Duke Power

Subject: Duke Energy Corporation
Oconee Nuclear Station, Units 1, 2 and 3
Docket Numbers 50-269, 50-270 and 50-287
Supplemental Information - Proposed Technical Specification Amendment
Generic Letter 96-04 - Spent Fuel Storage Racks (TSCR 2000-01)

REPLACEMENT MARK-UP PAGES

Insert 3 – Page 3.7.13-3 (replaces Figure 3.7.13-1)

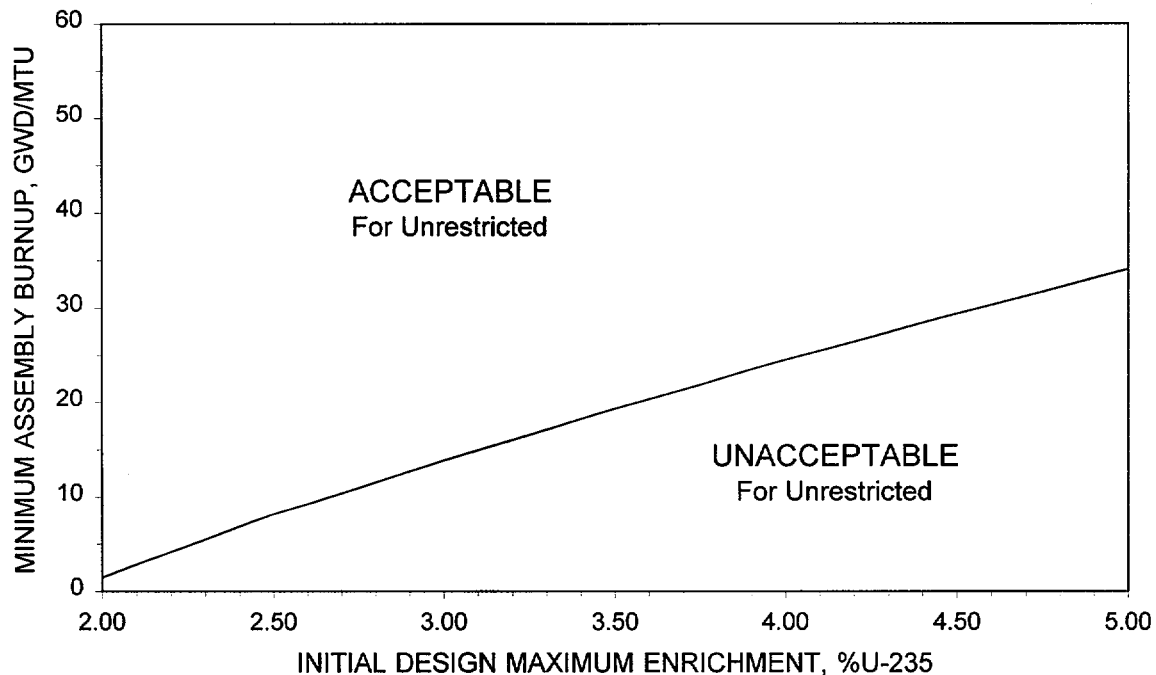
During performance of crosschecks of data sources for the basis of the LAR, the minimum burnups for Unrestricted fuel storage in the Oconee spent fuel pools were determined to have been incorrectly stated for 2.00 wt % U-235 fuel. This occurred as a result of typographic errors identified in the governing criticality analysis. This letter provides replacement pages to the LAR to correct these minor non-conservatisms.

Table 3.7.13-1 (page 1 of 1)
Minimum Qualifying Burnup versus Design Maximum Enrichment
for Unrestricted Storage in the Units 1 and 2 Spent Fuel Pool

Initial Design Maximum Enrichment (Weight% U-235)	Minimum Assembly Burnup (GWD/MTU)
1.91 (or less)	0
2.00	1.43
2.50	8.08
3.00	13.85
3.50	19.30
4.00	24.47
4.50	29.35
5.00	34.07

Insert 6 – Page 3.7.13-6 (replaces Figure 3.7.13-4)

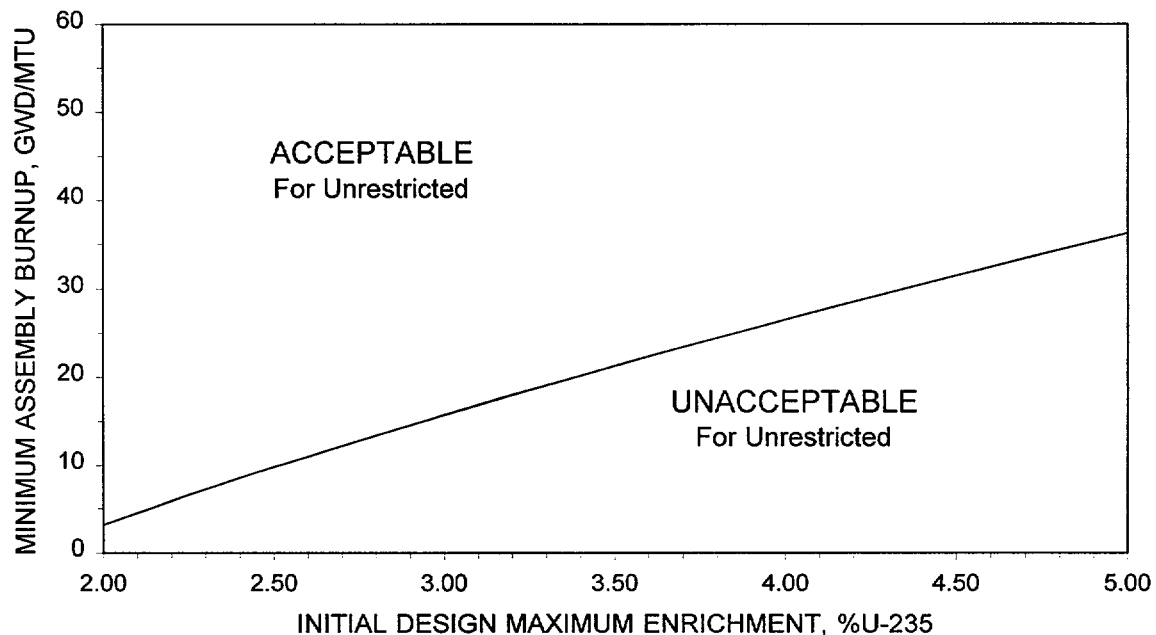
Table 3.7.13-4 (page 1 of 1)
Minimum Qualifying Burnup versus Design Maximum Enrichment
for Unrestricted Storage in the Unit 3 Spent Fuel Pool

Initial Design Maximum Enrichment (Weight% U-235)	Minimum Assembly Burnup (GWD/MTU)
1.81 (or less)	0
2.00	3.16
2.50	9.79
3.00	15.72
3.50	21.30
4.00	26.54
4.50	31.50
5.00	36.30

**Figure 5 - Oconee Units 1 and 2 Pool, Burnup Versus
Enrichment Limits**

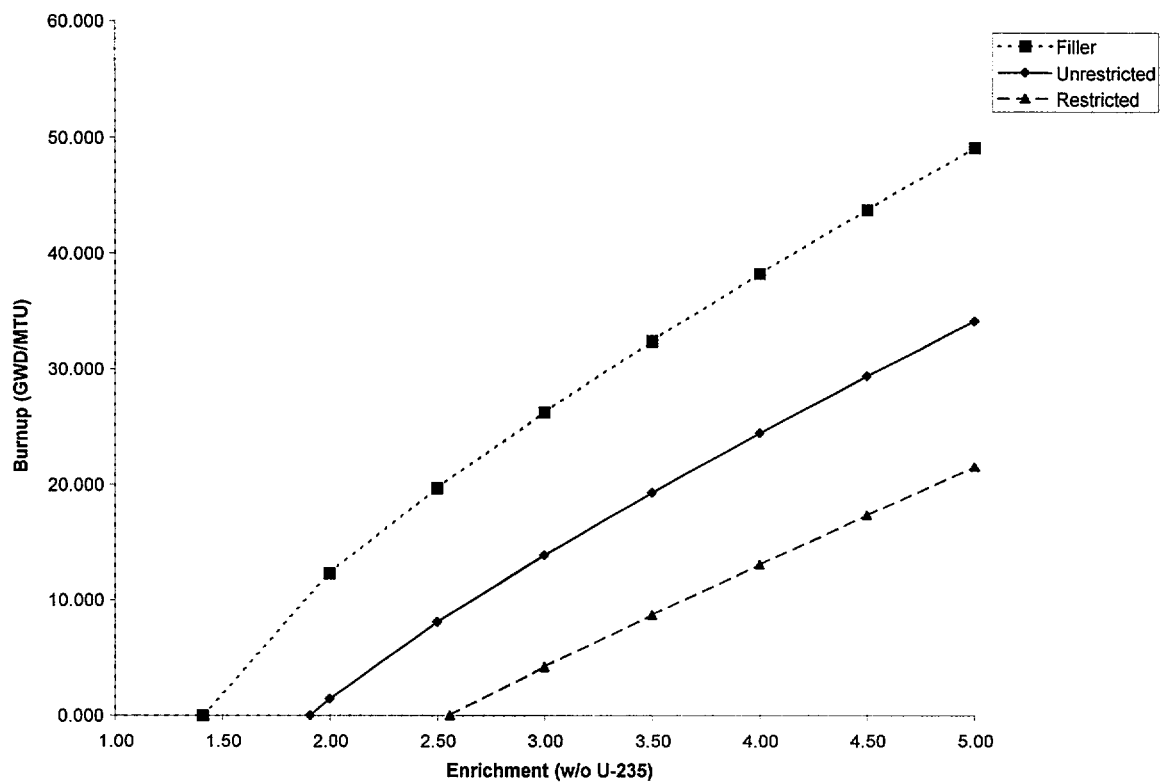
1. These replacement pages are dated February 15, 2001 to distinguish those of the original December 29, 2000 submittal.
2. Changes are identified on the replacement pages by a vertical line in the right margin.

Oconee 1/2 Pool		Oconee 3 Pool	
Initial		Initial	
Design Maximum	Minimum	Design Maximum	Minimum
Enrichment	Burnup	Enrichment	Burnup
(wt % U-235)	(GWD/MTU)	(wt % U-235)	(GWD/MTU)
1.91	0.00	1.81	0.00
2.00	1.43	2.00	3.16
2.50	8.08	2.50	9.79
3.00	13.85	3.00	15.72
3.50	19.30	3.50	21.30
4.00	24.47	4.00	26.54
4.50	29.35	4.50	31.50
5.00	34.07	5.00	36.30
